Agenda Item # 6

BOA-002682-2023

- To allow a duplex in a R-1 Single-Family Residential Urban District.

APPLICATION NUMBER	6555	DATE	November 6, 2023
APPLICANT	Kari Givens, Byrd Surveying		
REQUEST	Use Variance

SITE PLAN

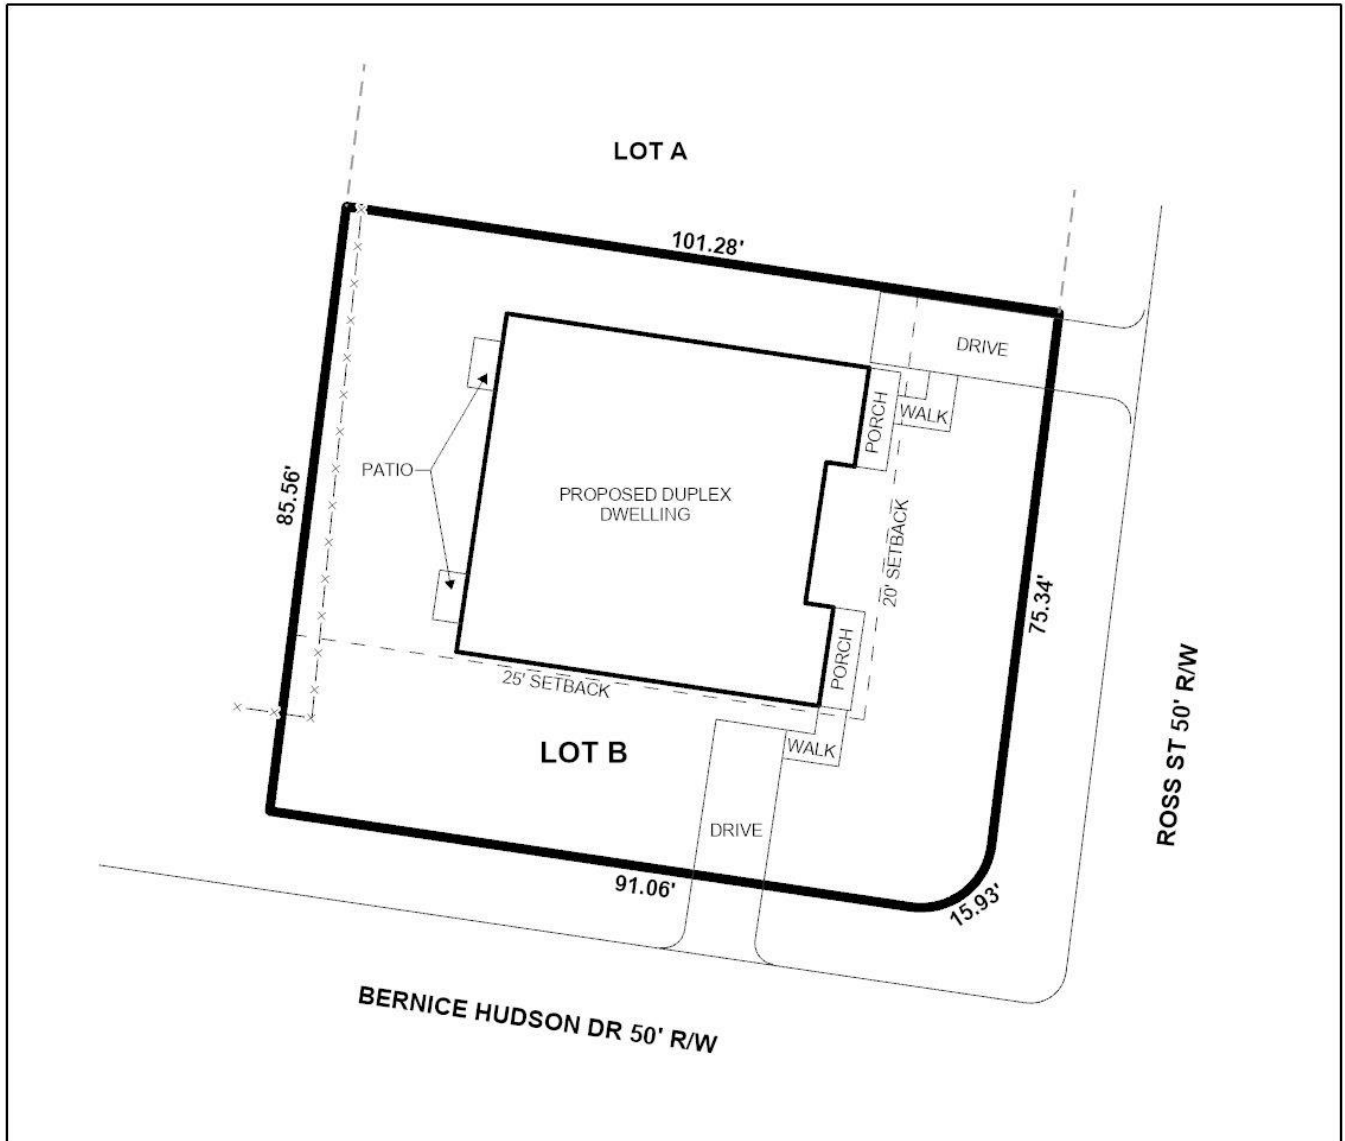
The site plan submitted illustrates a 20-foot minimum building setback abutting Ross Street and a 25-foot minimum building setback line abutting Bernice Hudson Drive. The site plan depicts two (2) driveways, each capable of accommodating one (1) vehicle. As duplexes are required to have 1.5 parking spaces per dwelling unit, the site plan should be revised to depict compliant parking, if approved.

- 1) Completion of the Subdivision process.
- 2) Revision of the site plan to depict compliant parking; and
- 3) Submittal of a revised site plan(.pdf and hard copy) prior to the issuance of permits.
